Notice of Allowability

10/700,256

EXAMINER'S AMENDMENT

REPLACEMENT SHEET

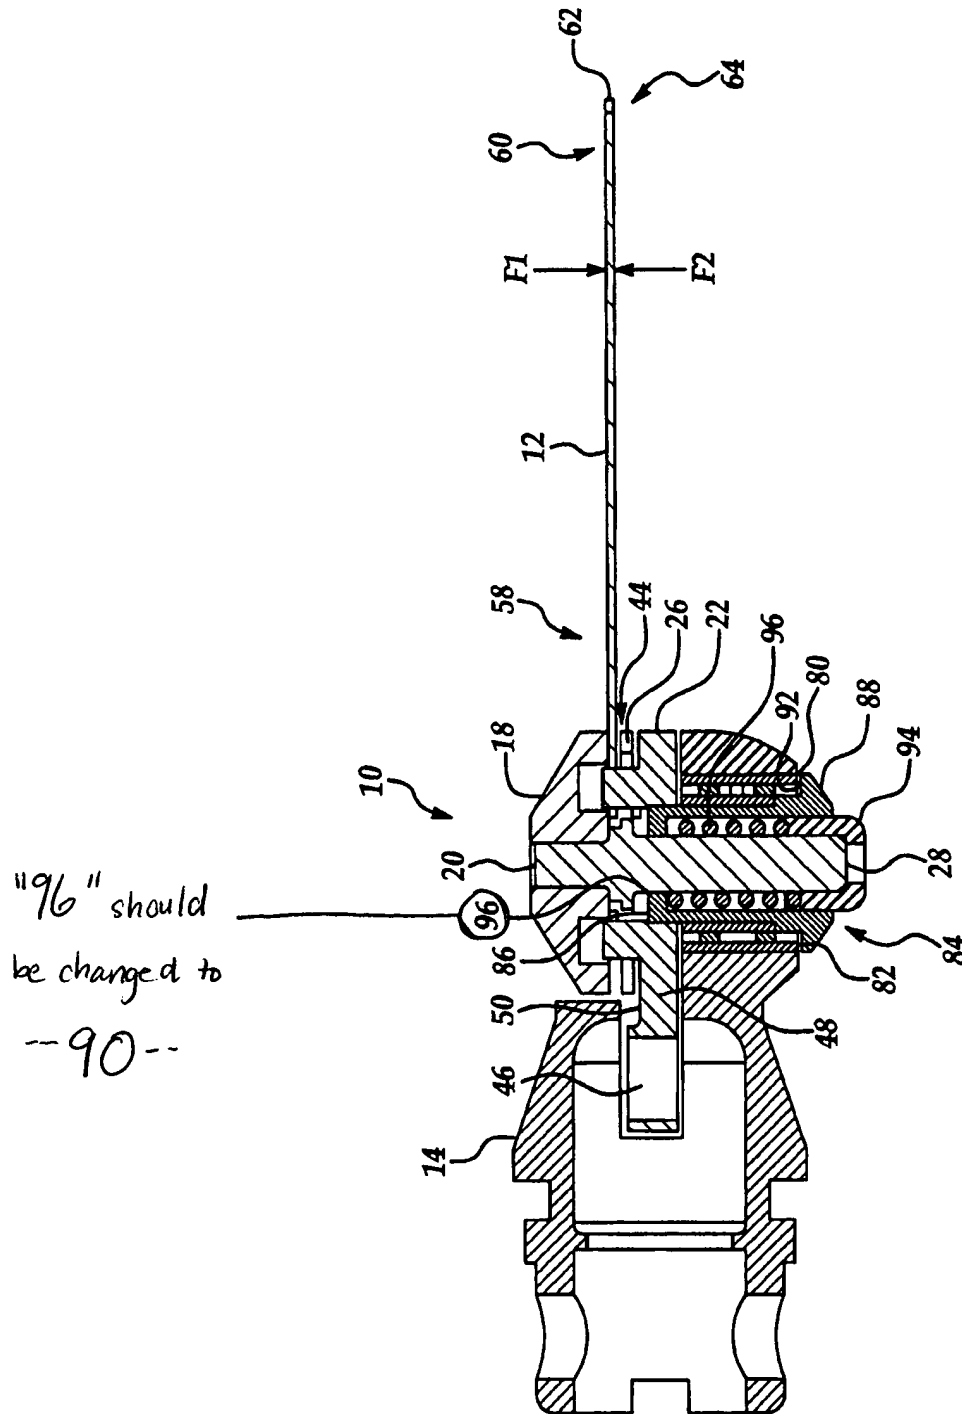
3. The following changes to the drawings have been approved by the examiner and agreed upon by applicant: In Figure 3 of the Amendments to the Drawings received on 27 April 2006, applicant does not include the reference sign **90**, referring to "cup aperture **90**" on page 8, paragraph 0041, which is also mentioned in the Ex Parte Quayle Action sent by examiner on 22 March 2006. It appears that applicant has added reference sign **96** in Figure 3, which should instead read as a reference sign **90**. In order to avoid abandonment of the application, applicant must make these above agreed upon drawing changes. The noted correction of Figure 3 of the drawings is attached.
